Access Compliance Report Public Rights-of-Way (Curb Ramps)

Main Street: RAINIER_DR Cross Street: SHASTA_WAY Location: NW

ADA ID: RPAT211022144959 Ramp Type: Type 1 - Perpendicular Diagonal Initial Pass/Fail: Pass Overall Compliance: No Severity Score: 4

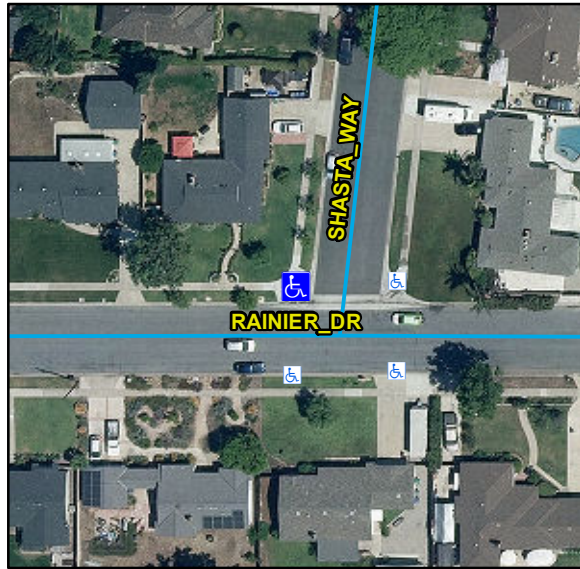
Codes/Mitigation Info/Possible Solution

Compliance	Description	Data	Compliance	Description	Data
N/A	Ramp Length (in)	77	N/A	Flare Type LT	
Yes	Ramp Width (in)	48			Sloped
Yes	Ramp Run Slope (%)	6.4	N/A	Flare Slope LT (%)	5.1
Yes	Ramp Cross Slope (%)	0.3	N/A	Flare Traversable LT	No
N/A	Landing Present	Yes	N/A	Flare Type RT	
N/A	Landing Length (in)	45			Sloped
Yes	Landing Width (in)	48	N/A	Flare Slope RT (%)	7.6
Yes	Landing Run Slope (%)	1.9	N/A	Flare Traversable RT	No
Yes	Landing Cross Slope (%)	0.3	Yes	DWS Provided	Yes
N/A	Landing Movement Obstructed?	Yes	Yes	DWS Contrast	Yes
	Landing Movement Type	Curb	Yes	DWS Length (in)	36
N/A	Landing Shared	Yes	Yes	DWS Full Width	Yes
N/A	Clear Space	Yes	Yes	DWS Offset Left (in)	0
N/A	Clear Space To Crosswalk (in)	48	Yes	DWS Offset Right (in)	N/A
N/A	Marked Crosswalk 1	No	N/A	Marked Crosswalk 2	No
	Crossing 1 Direction	S		Crossing 2 Direction	E
	Marked Crosswalk 1 Width (in)	N/A		Marked Crosswalk 2 Width (in)	N/A

Remove & Replace Landing.

R304.2.1, STD 1115
